West County energy center

Sufficiency Responses

From: Barbara_P_Linkiewicz@fpl.com
Sent: Tuesday, June 07, 2005 5:12 PM
To: Kosky, Ken
Cc: Rachel_Godino@fpl.com; John_Gnecco@fpl.com
Subject: West County Energy Center - DEP SED comments

Re: Florida Power and Light West County Energy Center Power Plant Siting Application
PA No. 05-47
DEP Case No. 05-0745
DOAH Case No. 05-1493EPP

ATTACHMENT SFWMD-1

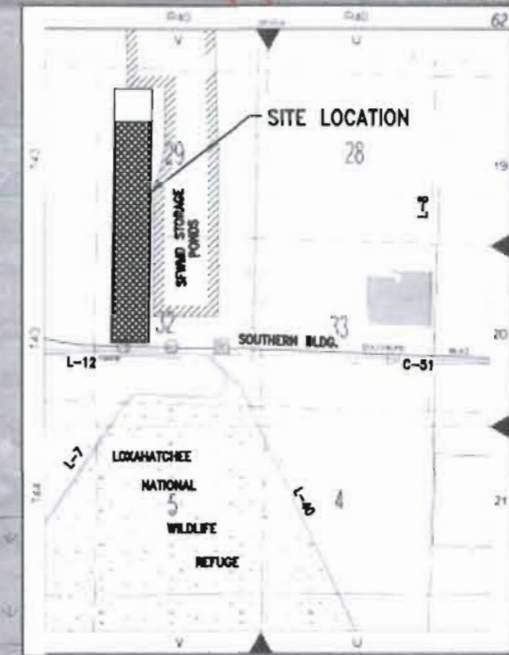
- (1) The sketches provided need to be supported with recent aerial photography of the proposed site. SFWMD-1
- (2) The drawings must show the SFWMD right-of-way lines on both the plan and profile view. SFWMD-2

UPDATED SCA FIGURES 3.5.0-3

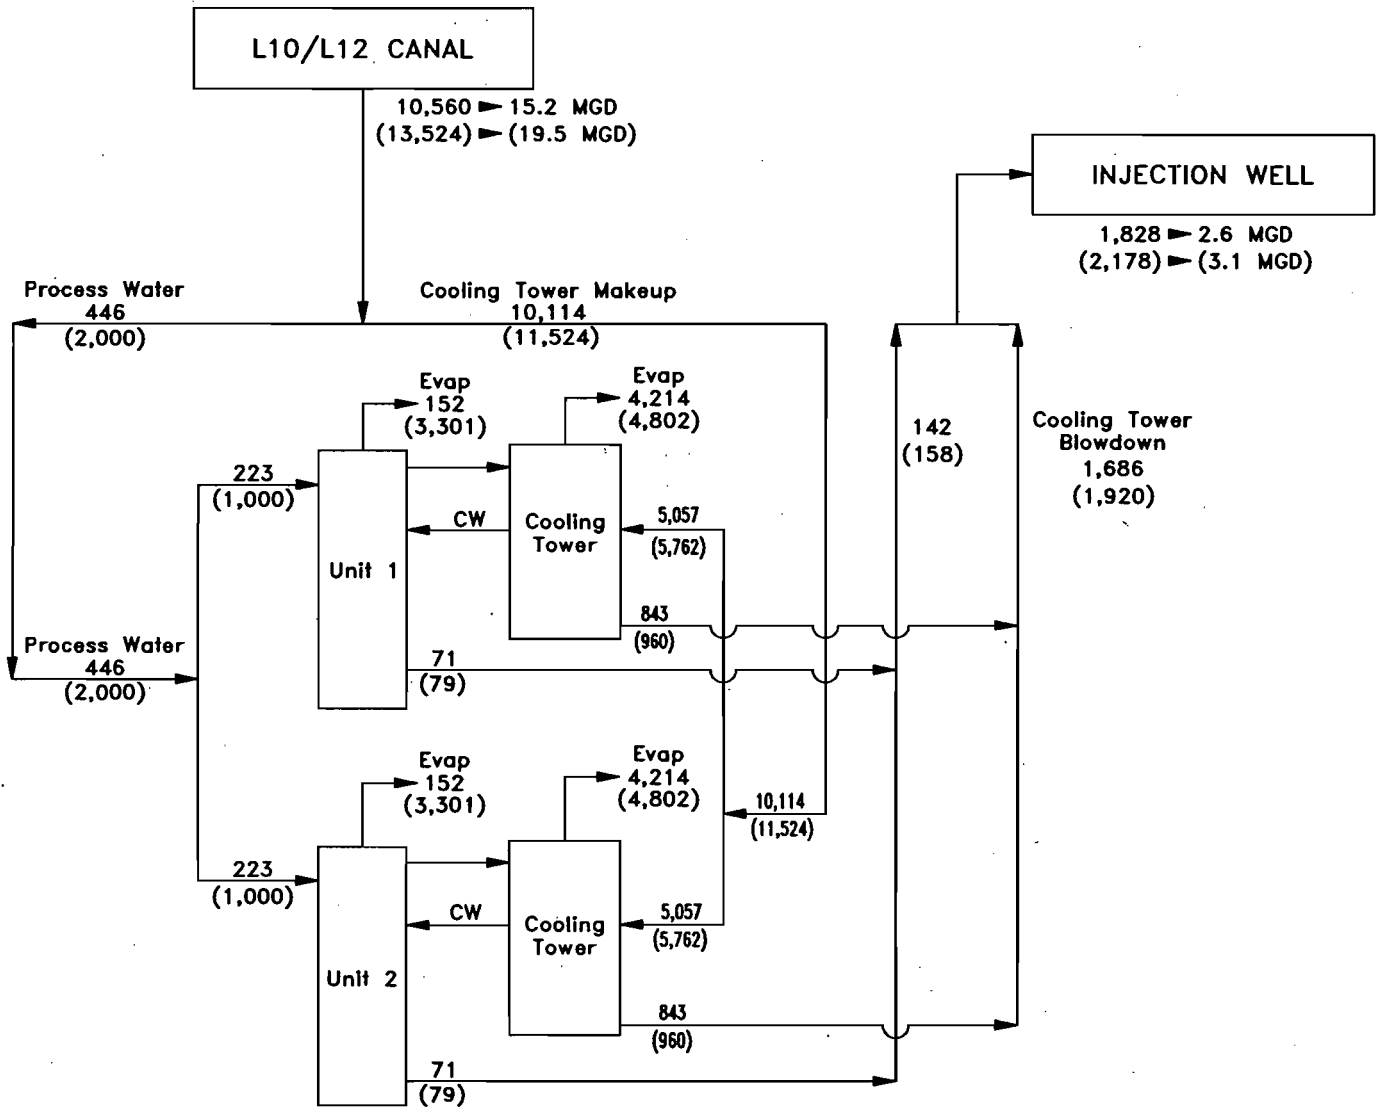
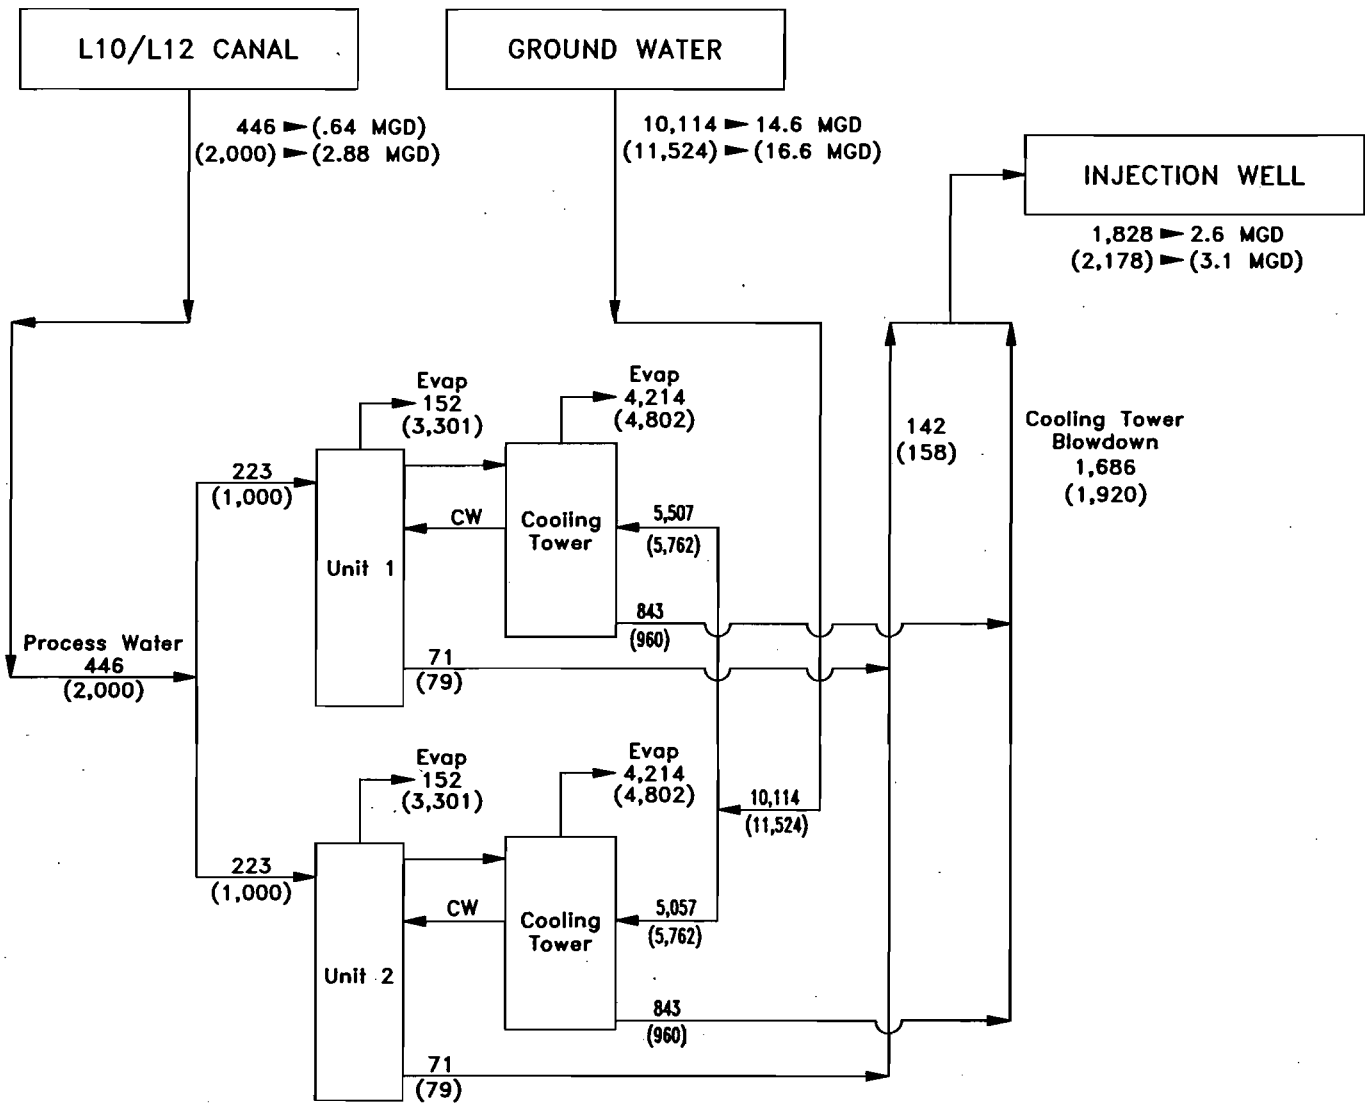
- SFWMD-17
- (17) In Section 3.0 of the SCA, the demand from the L-10/L-12 canal for the cooling towers and process water is shown on the water mass balance chart as 15.20 million gallons per day (MGD) with the maximum demand as 19.5 MGD. When water from the Upper Floridan Aquifer (UFA) is used as an emergency supply, the total average demand is 15.24 MGD and the maximum demand is 19.48 MGD. Please clarify and revise, as necessary.

Response 17: The difference between the numbers is due to truncation/round off when converting from gallons per minute (gpm) to million gallons per day (MGD). Also, note 4 in Figure 3.5.0-4 should read "Flows are based on 6 cycles of concentration in CT." Replacement pages for these figures are included as Attachment SFWMD-17.

FIGURE **6**

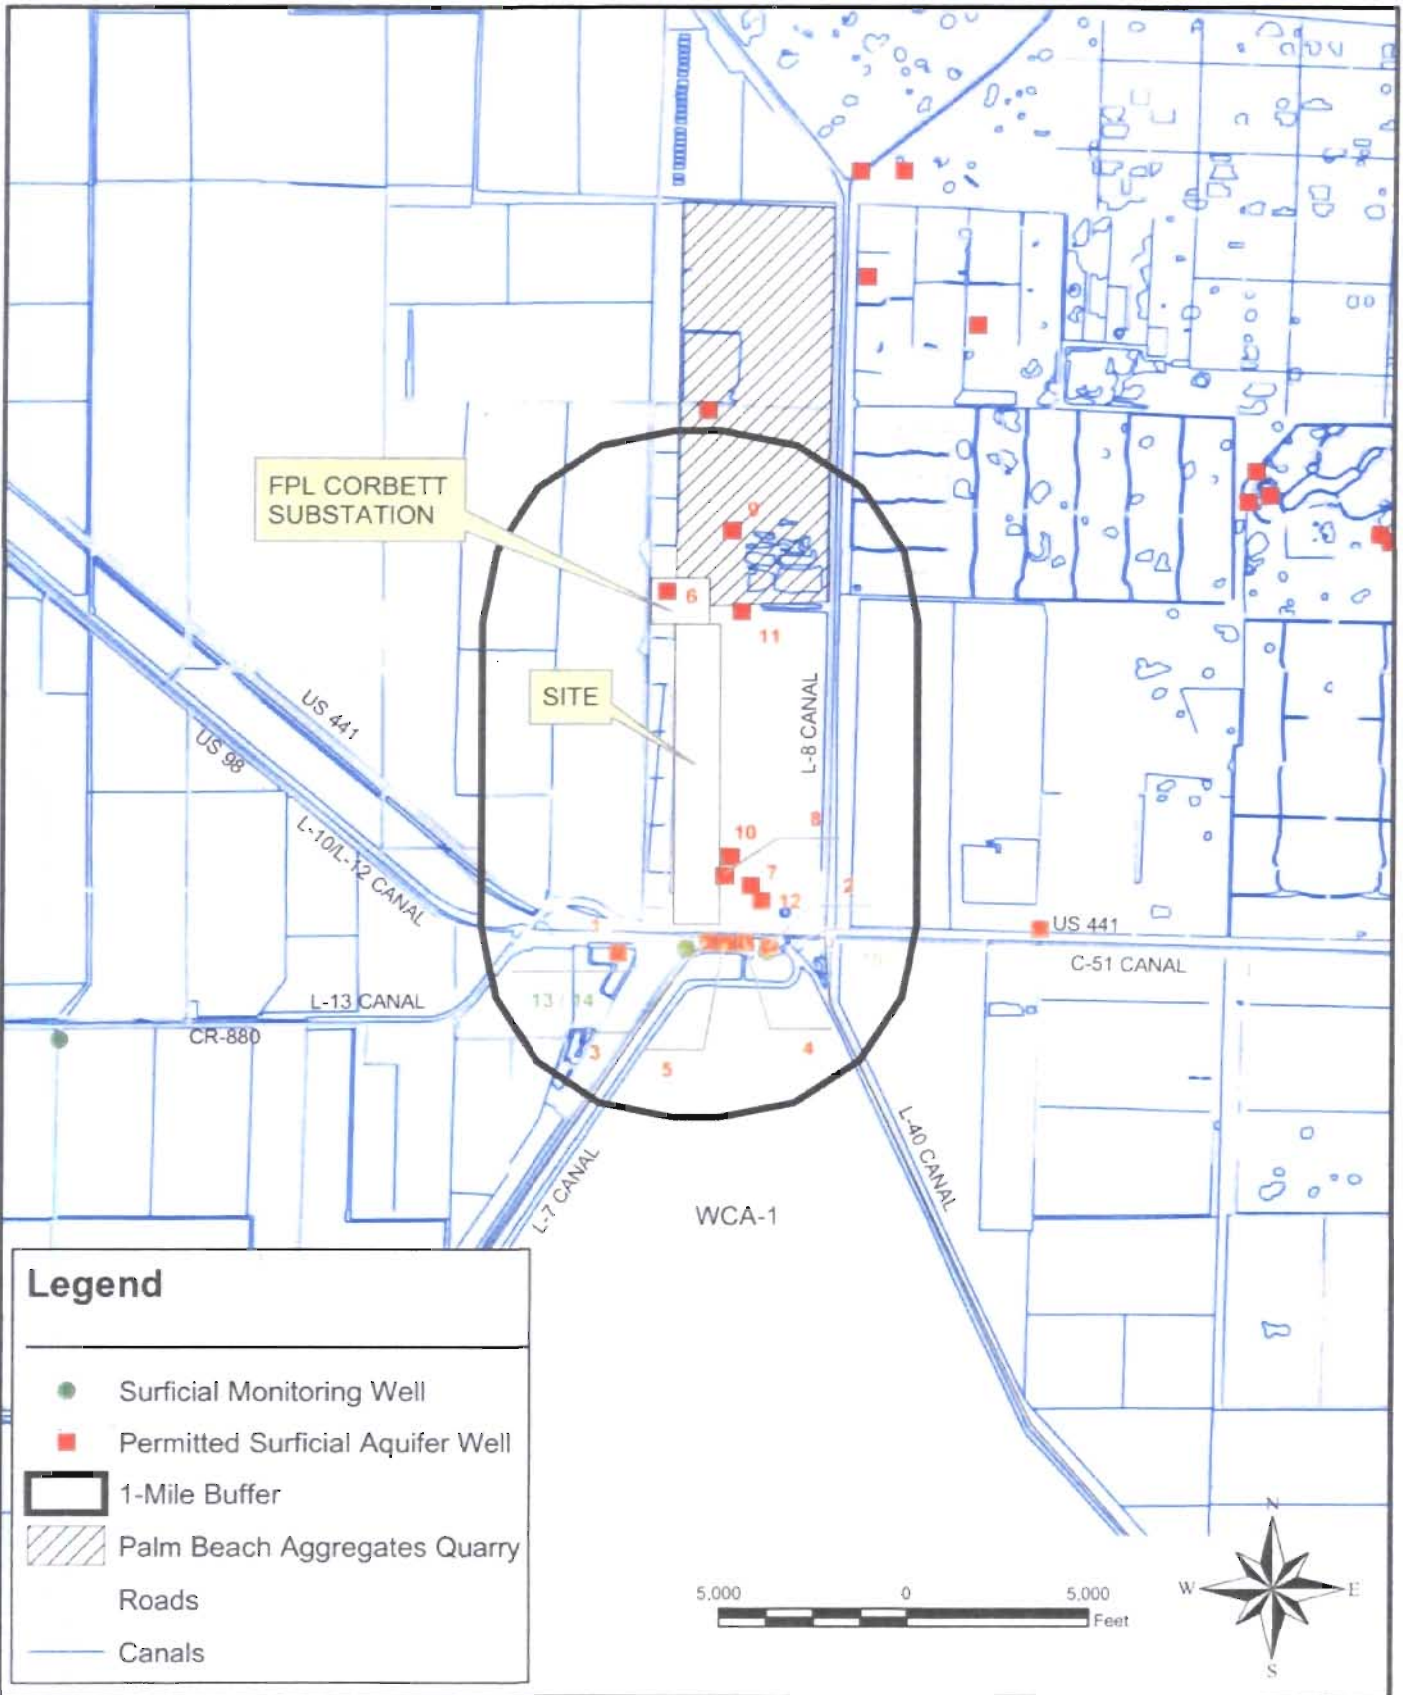
- SFWMD-20
- (20) In Section 2.0 of the SCA, potable water supply wells are shown on Figure 2.3.3-1. In Appendix 10.1.8, Figure 6 shows the location of other Surficial Aquifer Wells. Other wells that do exist, some of which are located on adjacent Palm Beach Aggregates property, are not shown and were not included in the modeling. Please submit revised modeling that includes these wells.

SFWMD Comment 20: In Section 2.0 of the SCA, potable water supply wells are shown on Figure 2.3.3-1. In Appendix 10.1.8, Figure 6 shows the location of other Surficial Aquifer Wells. Other wells that do exist, some of which are located on adjacent Palm Beach Aggregates property, are not shown and were not included in the modeling. Please submit revised modeling that includes these wells.

Response 20: The well information shown in Figure 2.3.3-1 of the SCA, while labeled potable water supply wells, included all wells obtained from the SFWMD's DBHYDRO database. These wells are used primarily for monitoring; the figure title should not have referred to potable wells. Table 2.3.3-2 in the SCA provides a listing of all water use permits within 5 miles of the Site including wells located on Palm Beach Aggregates property. The information in this table was obtained from the SFWMD, and it includes all water use designations and all water sources (surface water and groundwater). No existing water use permit with 5 miles of the Site designates the Upper Floridan aquifer as the source. Table 2.3.3-2 provides a location reference to the section, township, and range. Therefore, the public land survey system (PLSS) grid was included in Figure 2.3.3-1 for reference. Figure 6 in Appendix 10.1.8 of the SCA shows all surficial aquifer monitoring and supply wells within the UIC Program area of review. Figure 6 has been updated to provide reference to the well inventory contained in Table 3 of Appendix 10.1.8 of the SCA (Table 3 and the updated Figure 6 are presented in Attachment SFWMD-20). The information provided in Figure 6 and Table 3 was

Response 21: Table 3 and Figure 6 (included in the SCA) were revised to include cross references between the Figure and the Table and are included in Attachment SFWMD-20.

Figure 4.
Upper Floridan Aquifer Production Well
Construction Details (Typical)
FPL West County Energy Center, Palm Beach County, Florida
Source: Golder, 2005.

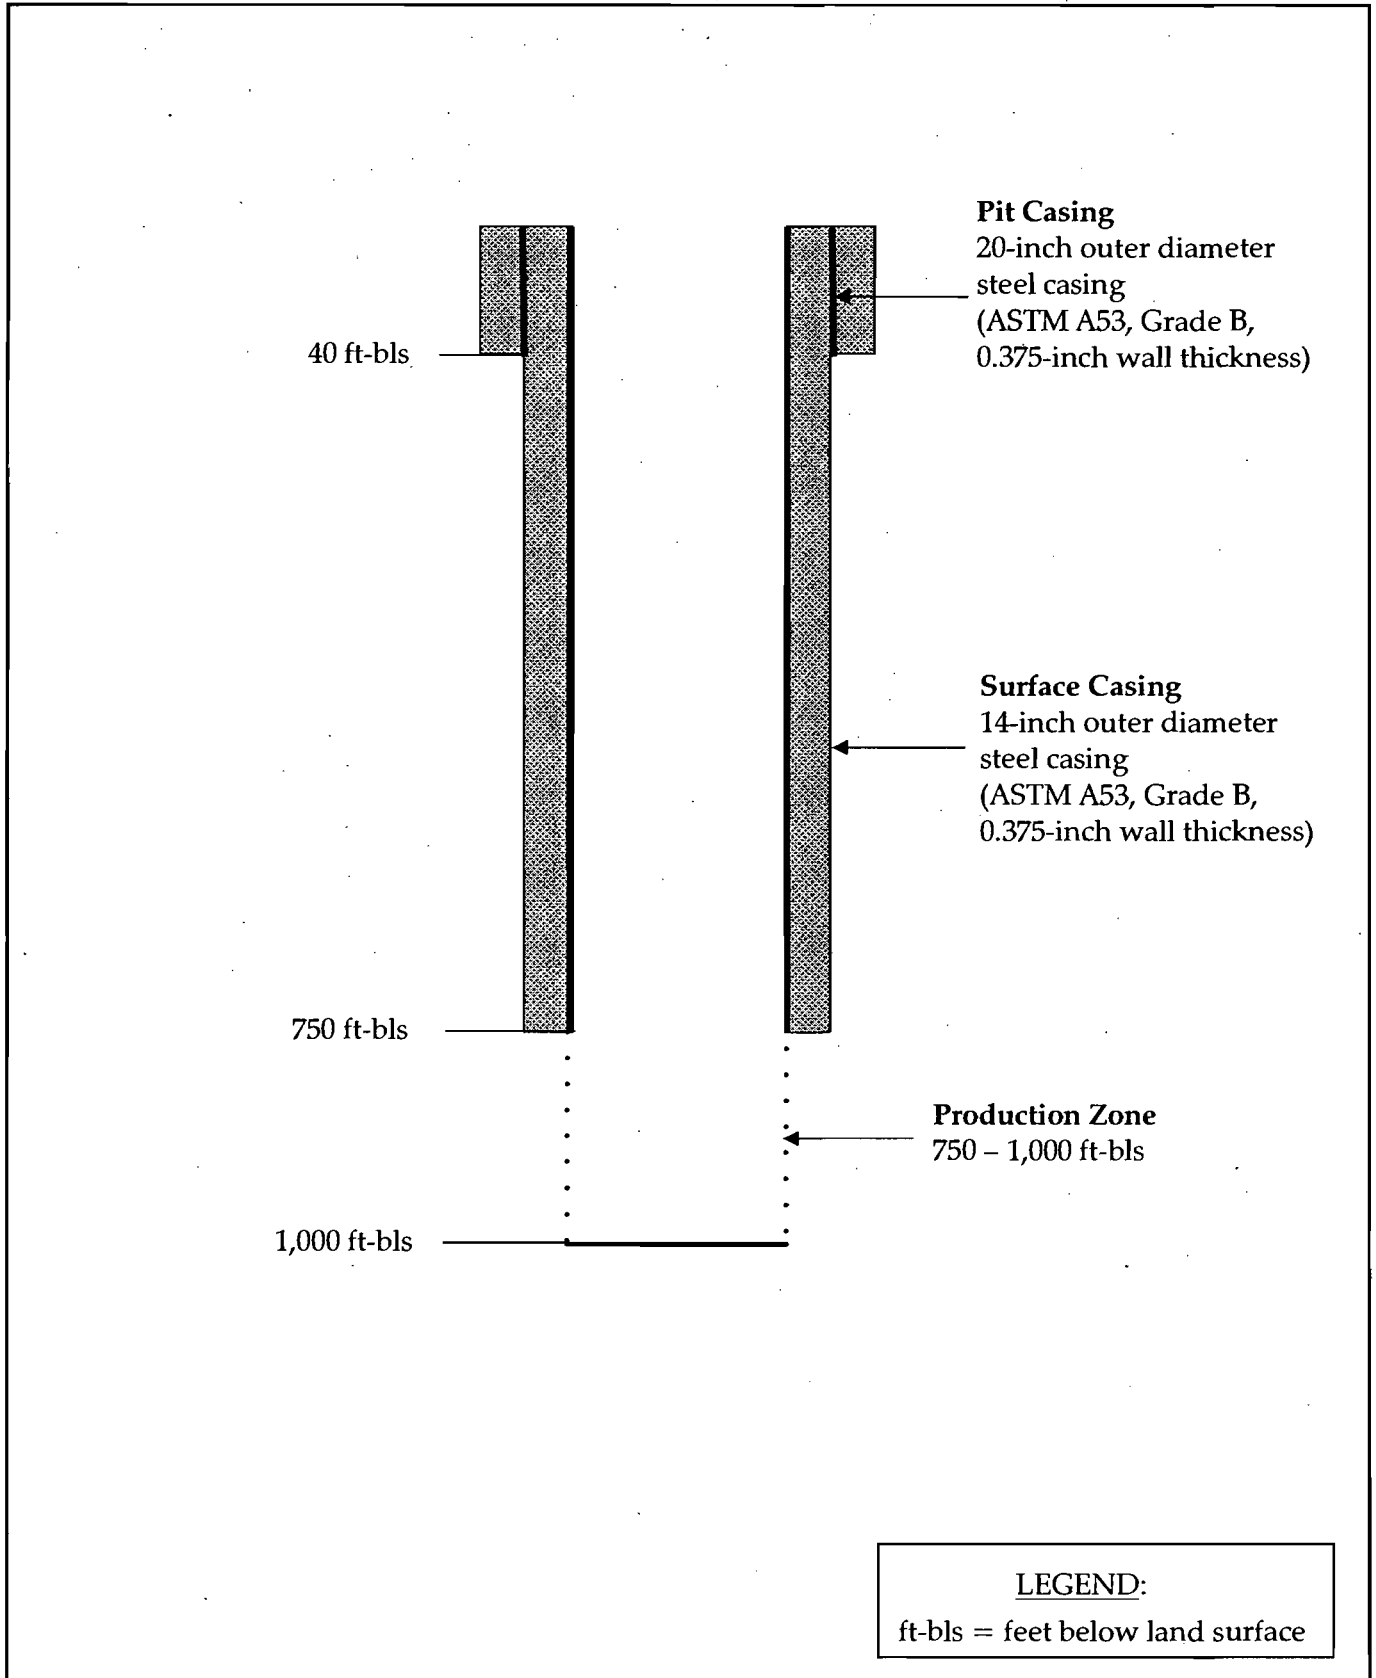
modeling to determine impacts of the emergency withdrawals was done for the UFA, between 750 and 1350 feet bls and for LFA PZ-1 between 1500 and 1650 bls. The site map for the facility (Chapter 3, Sheet 3) does not show any UFA well sites. The proposed UFA wells are not described in the construction details, which only describe the drilling and testing of the Deep Injection Wells (Section 4.1.5) and exploratory well (Appendix 10.1.8). Please clarify and revise, as necessary.

Response 22: The exploratory well will be converted to a dual-zone monitoring well to provide monitoring for the northern most DIW. Other monitoring wells are proposed for subsequent DIWs and identified as I.D. Number 34, Monitor Wells, as shown on Figure 3.2.0-4 of the SCA.

Upper Floridan Aquifer (UFA) wells are identified in Chapter 3, Figure 3.2.0-4, Plot Plan. These are I.D Number 31, Groundwater Wells, Backup Production Wells. The most northerly UFA well is located just south of I.D. Number 35, Exploratory/Dual Zone Monitoring Well (immediately south of the large stormwater pond-I.D. Number 27), adjacent to the proposed I.D. Number 19, Underground Injection Well(s), 1-unit capacity. Another Groundwater Backup Production Well is located approximately 2,000 ft due south.
